ROADWAY PLAN
STA. 9+00 TO STA. 14+00
INTERSTATE ROUTE H-1 REHABILITATION
Middle Street to Vicinity of Ward Avenue
FAP NO. IM-HI-1(269)

"AS-BUILT"

INTERSTATE ROUTE H-1 REHABILITATION
Middle Street to Vicinity of Ward Avenue
FAP NO. 1M-HI-1(269)

SHEET No. R-07 OF 43 SHEETS

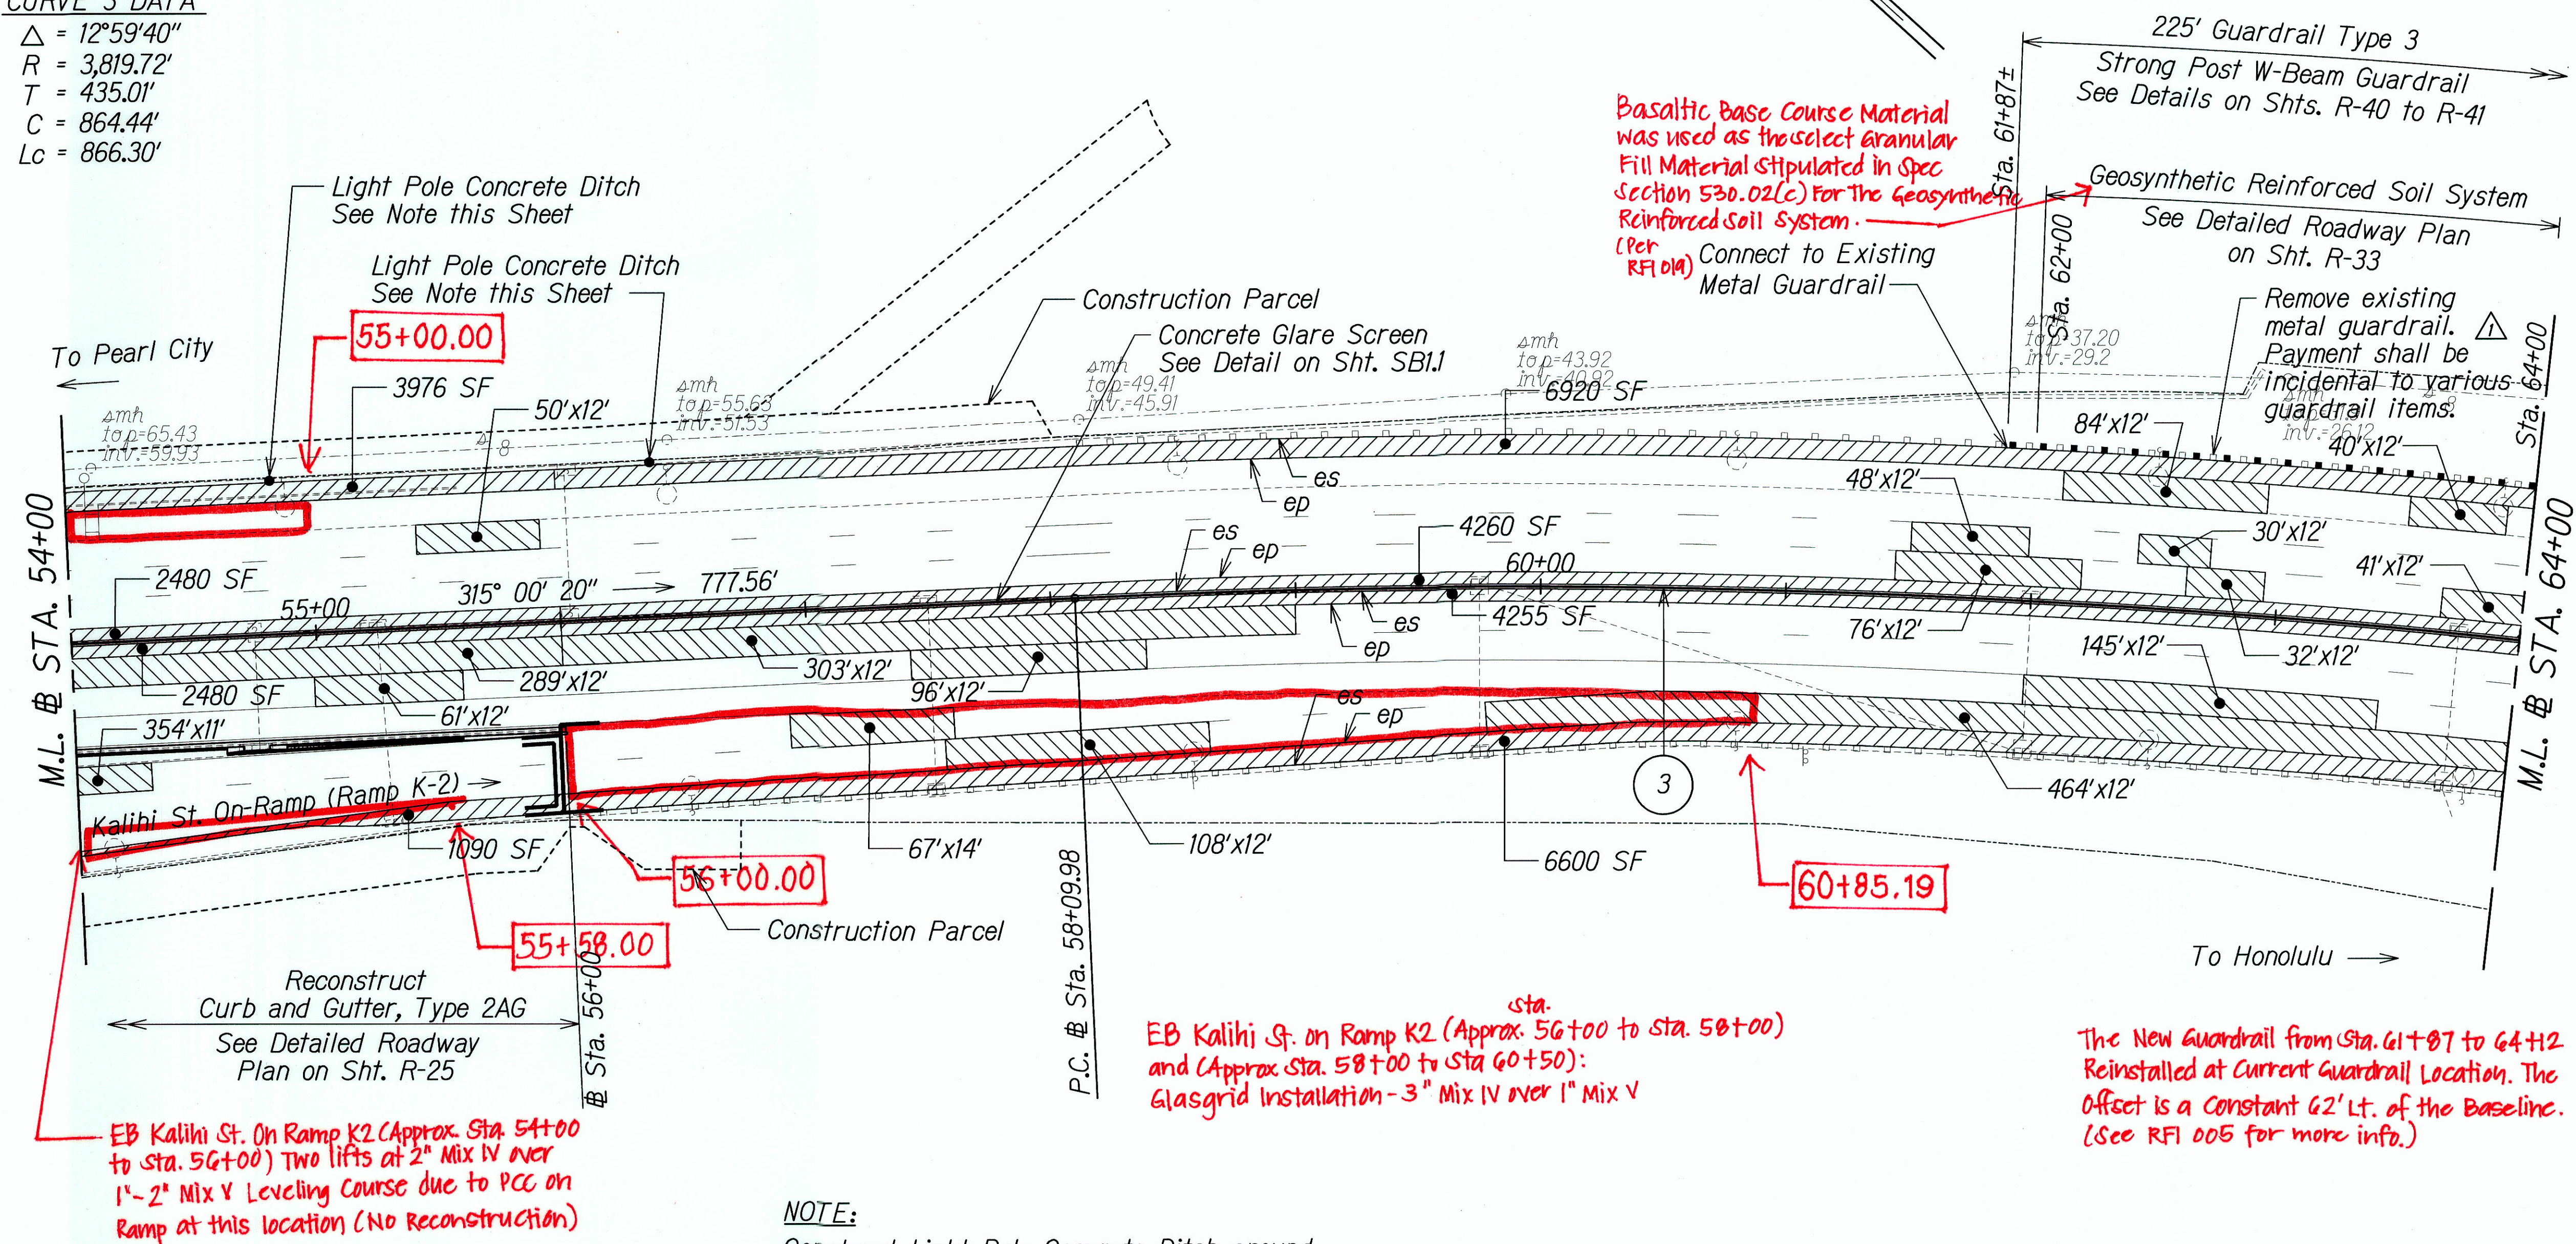
EB Kalihi St. On Ramp K2 (Approx. Sta. 54+00 to Sta. 56+00) Two lifts at 2" Mix IV over 1"-2" Mix V Leveling Course due to PCC on Ramp at this location (No Reconstruction)

EB Kalihi St. on Ramp K2 (Approx. Sta. 56+00 to Sta. 58+00) and (Approx. Sta. 58+00 to Sta. 60+50): Glasgrid Installation - 3" Mix IV over 1" Mix V

The New Guardrail from Sta. 61+87 to 64+12 Reinstalled at Current Guardrail Location. The Offset is a Constant 62' Lt. of the Baseline. (See RFI 005 for more info.)

SHEET No. R-10 OF 43 SHEETS

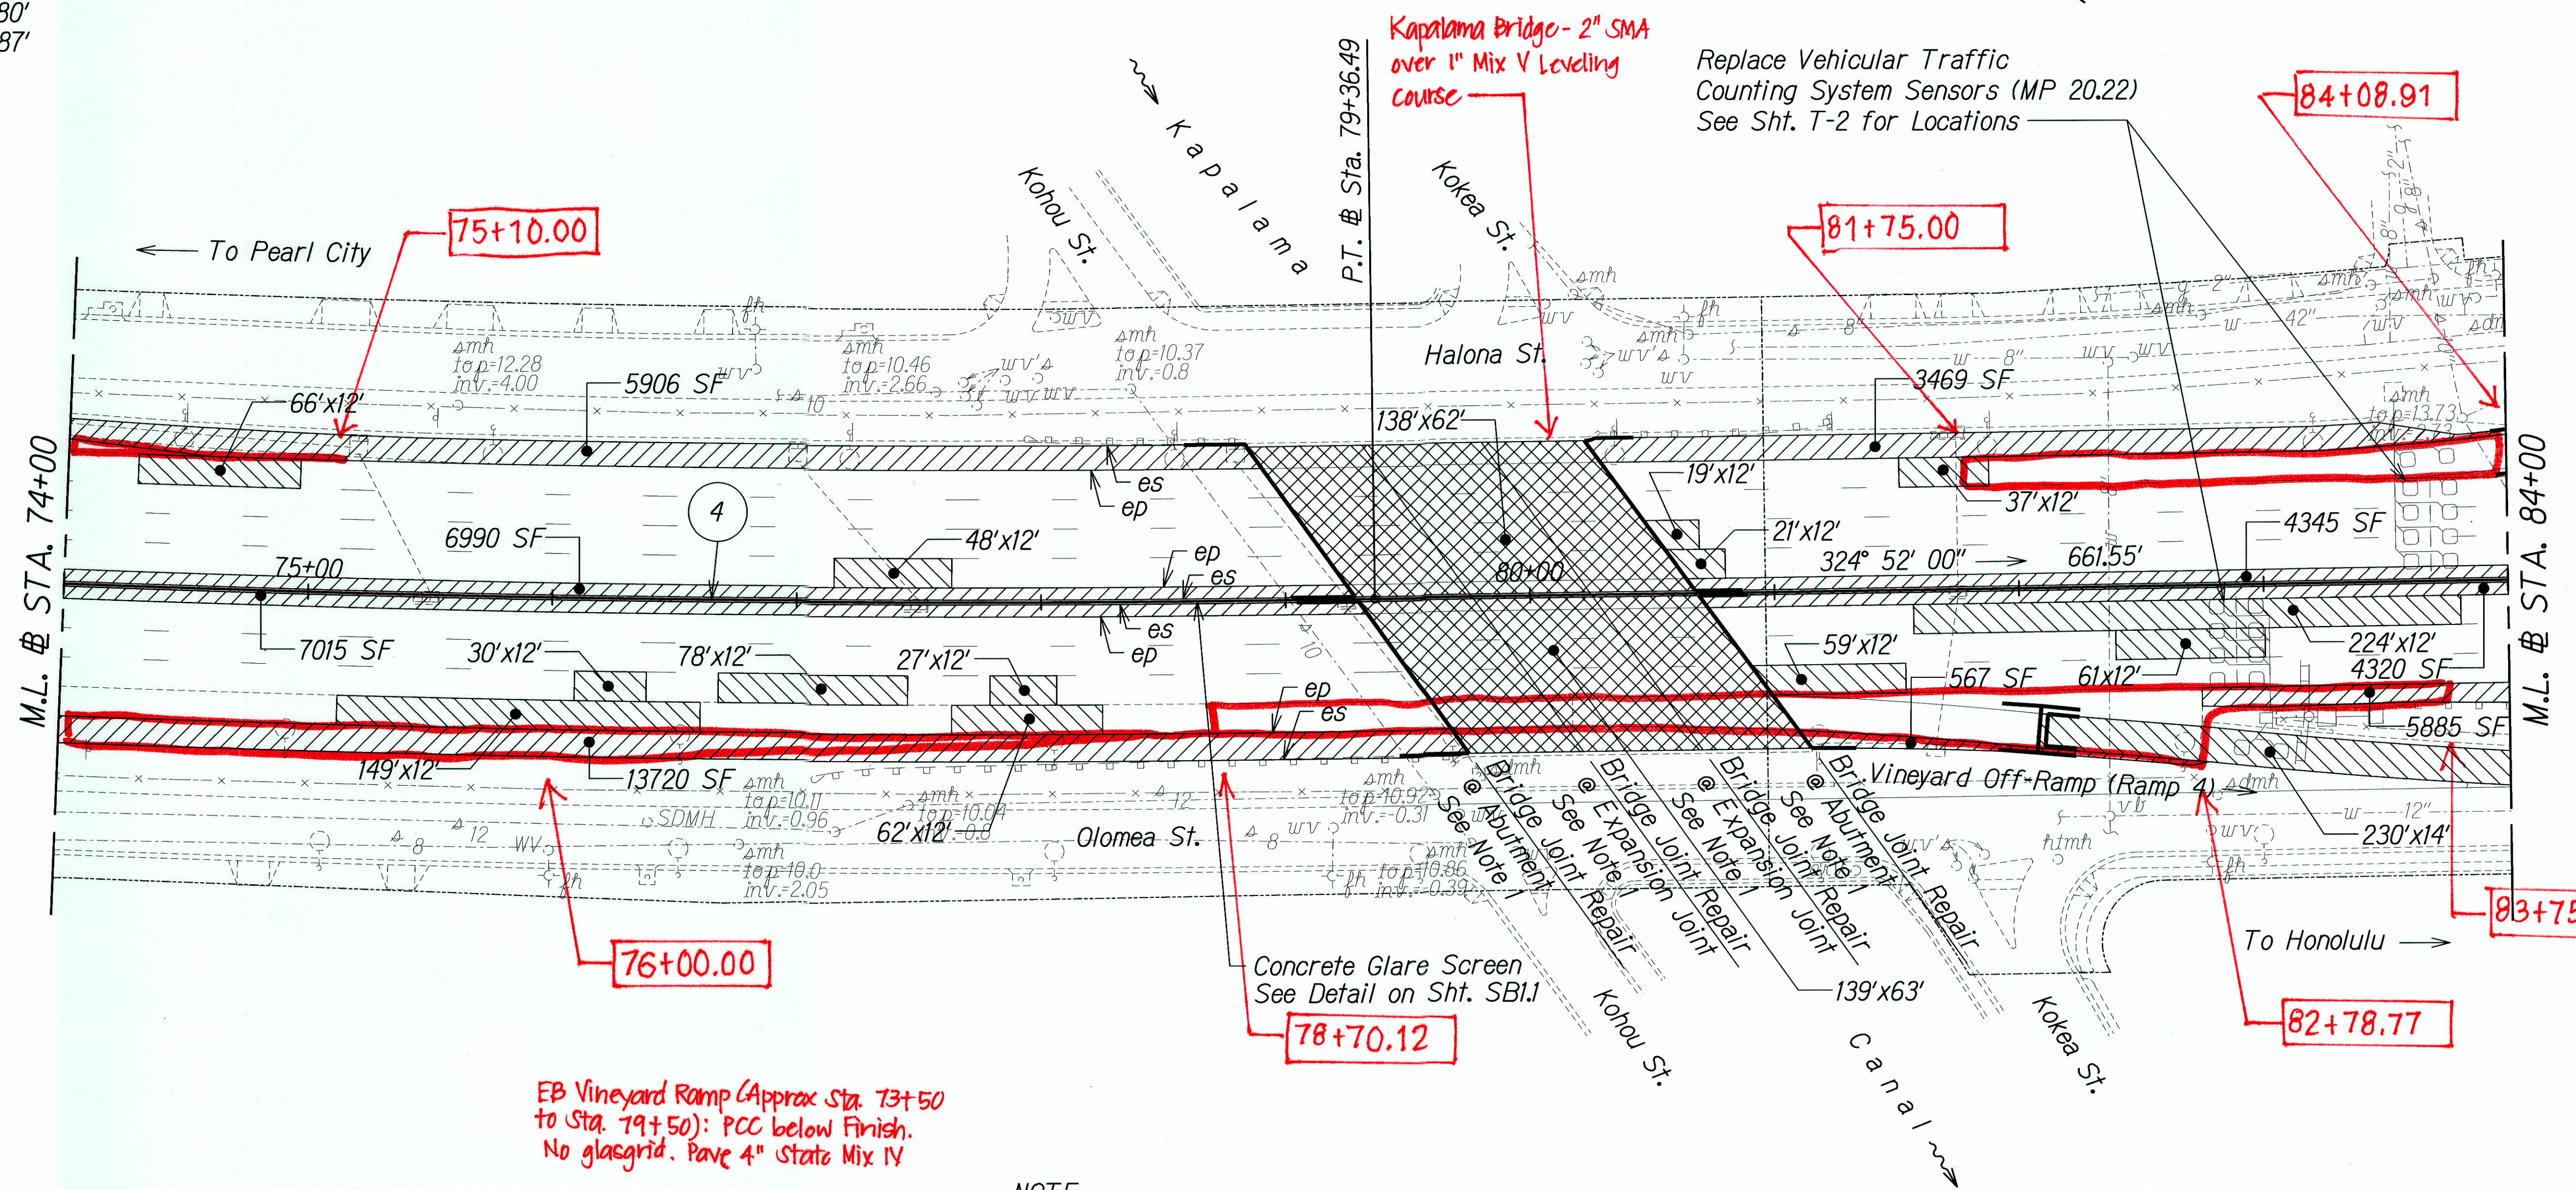
EB Vineyard Ramp (Approx Sta. 73+50 to Sta. 79+50): PCC below Finish. No glasgrid. Pave 4" State Mix IV

SHEET No. R-12 OF 43 SHEETS

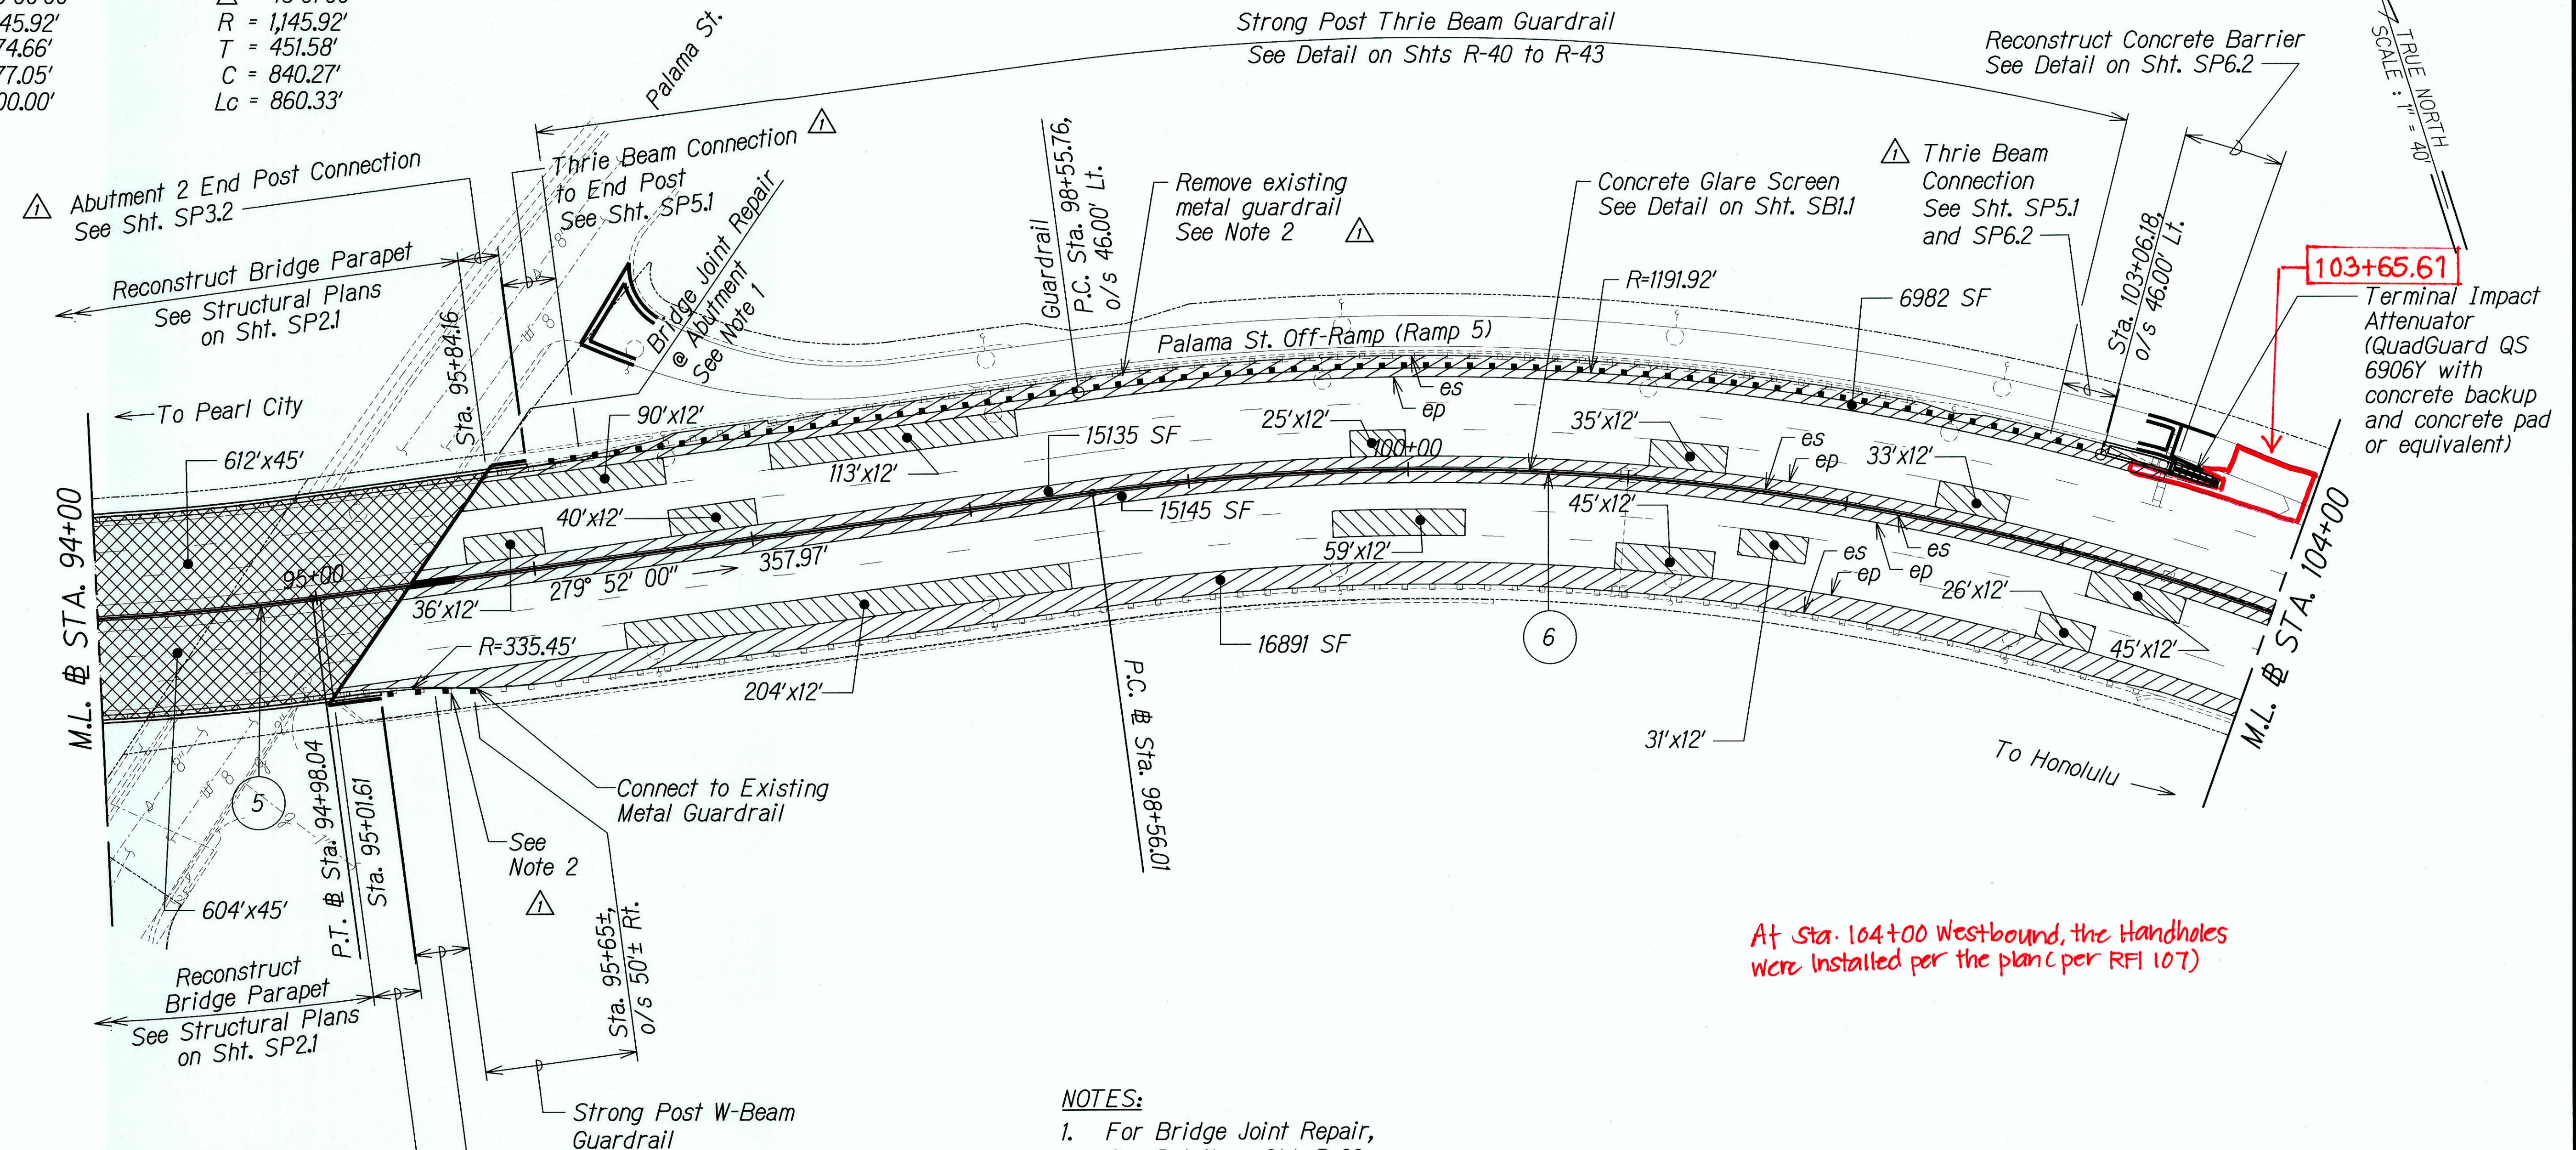
HDC constructed the Guardrail while the Pavement was still Fresh Per RFI 156. See Attached drawing for more info.

At Sta. 104+00 Westbound, the Handholes were installed per the plan (per RFI 107)
